CLINCH RIVER

BREEDER REACTOR PROJECT

**PRELIMINARY
SAFETY ANALYSIS
REPORT**

VOLUME 17

Figure 001.269-1
Plenum Fission Gas Release Versus Time for Appendix D EOEC Top Base Case

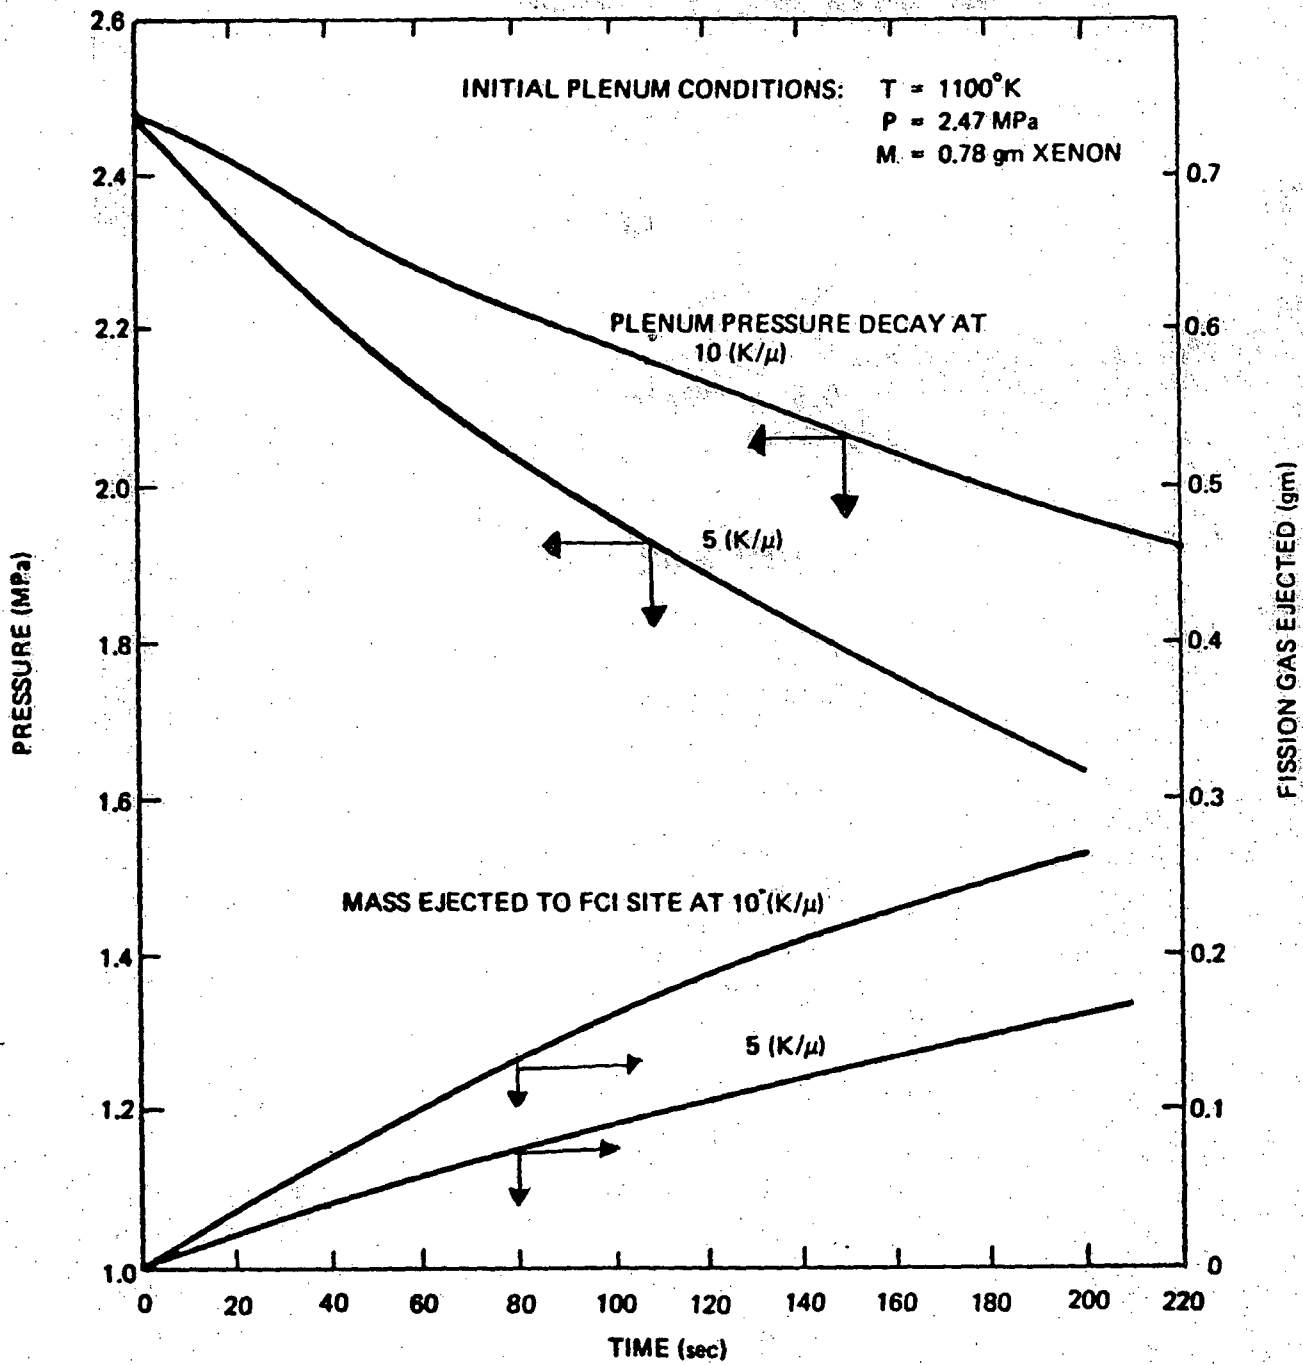
Question 001.269 (Section D5.1.6)

The results of the calculations which show that the potential flow within the pin of fission gas from the plenum to the original FCI failure site would not be of consequence during the time scale of interest for the FCI transient (approximately 100 msec) are shown in Figure Q001.269-1. The equations shown in Table Q001.269-1 were used to calculate the plenum pressure decay and the mass of plenum fission gas transported to the failure site as a function of time. Table Q001.269-2 gives the parameter values used in the equations and indicates their source. The value for the parameter (P_0), the coolant pressure at the failure site, was held constant and was conservatively selected to be the lowest pressure in the FCI zone obtained from the SAS/FCI calculations.

In the calculation shown in Figure Q001.269-1 the ratio of the effective permeability to the dynamic viscosity was conservatively evaluated at five and ten times the selected best estimate values shown in Table Q001.269-2.

Figure Q001.419-1. Core Exit Coolant Temperatures For Double-Ended Rupture At R.V. Inlet Sleeve As Calculated By The DEMO Code (Single Phase Flow Model)

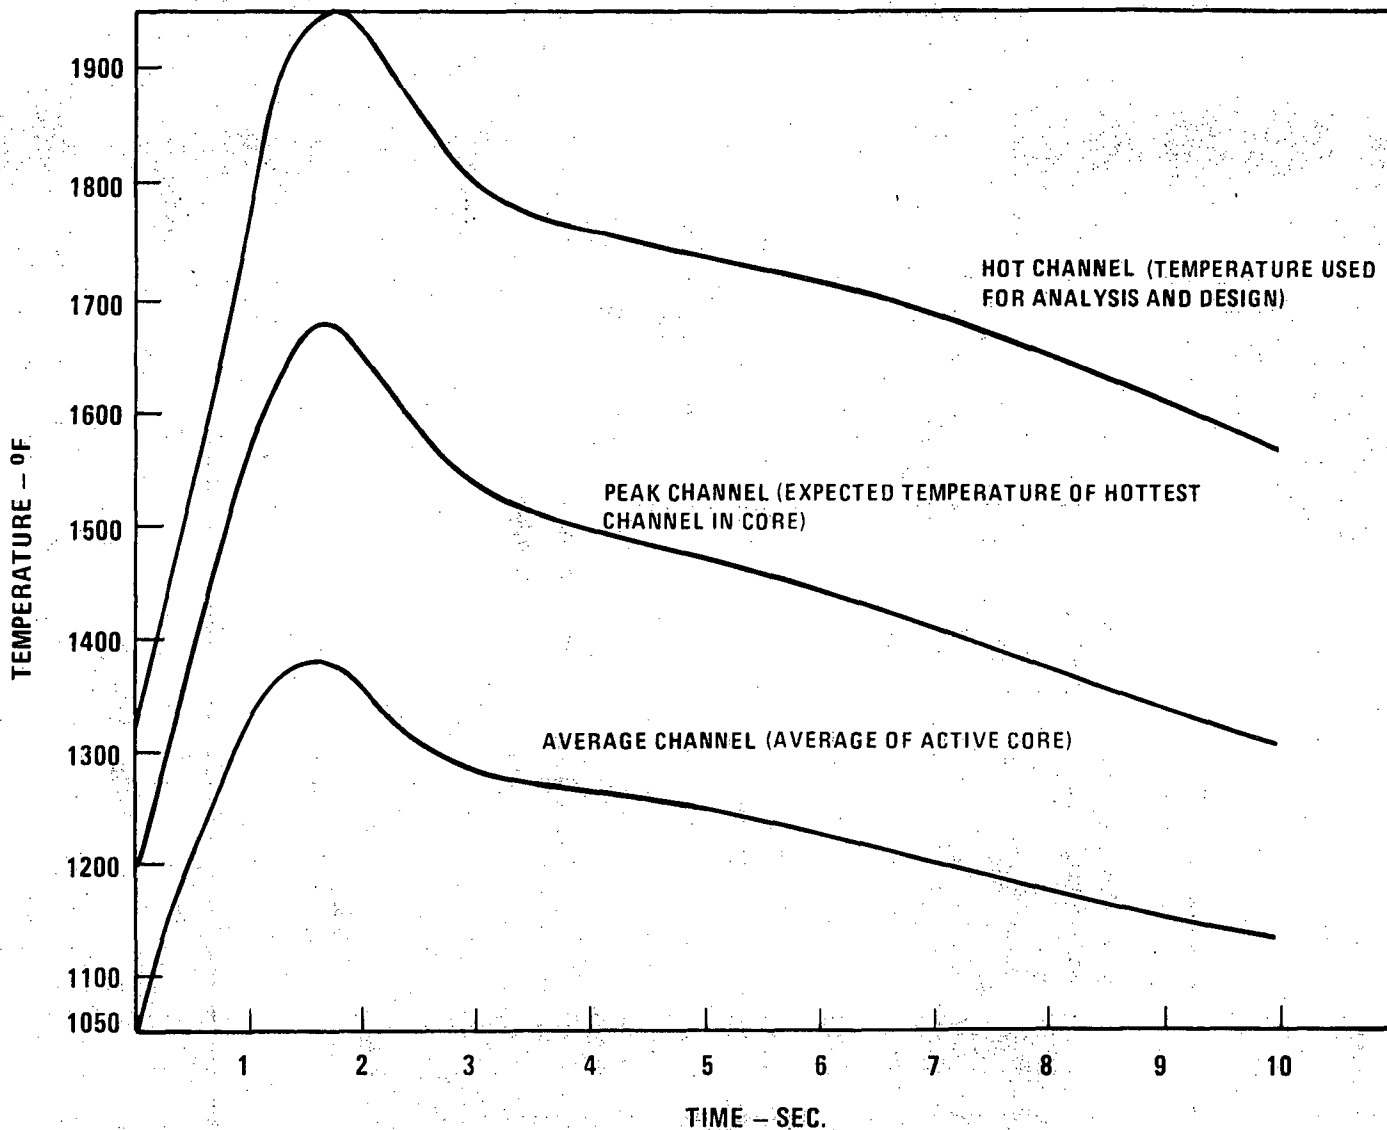
Question 001.419 (E3.1.3.2 and E3.1.3.4)

Figure Q001.419-1. (Note that the analysis assumes single phase sodium flow up to 1950°F which is not realistic, but serves to demonstrate the margin resultant from stacking uncertainties). This analysis was done from the plant TDM condition for the hottest channel in the active core at steady state. The hot channel, which is used for pipe rupture analysis contains the hot channel factors of reference Q001.419-1, whereas the expected hot channel does not. As shown the hot channel factors provide 265°F of margin for the reactor uncertainties.
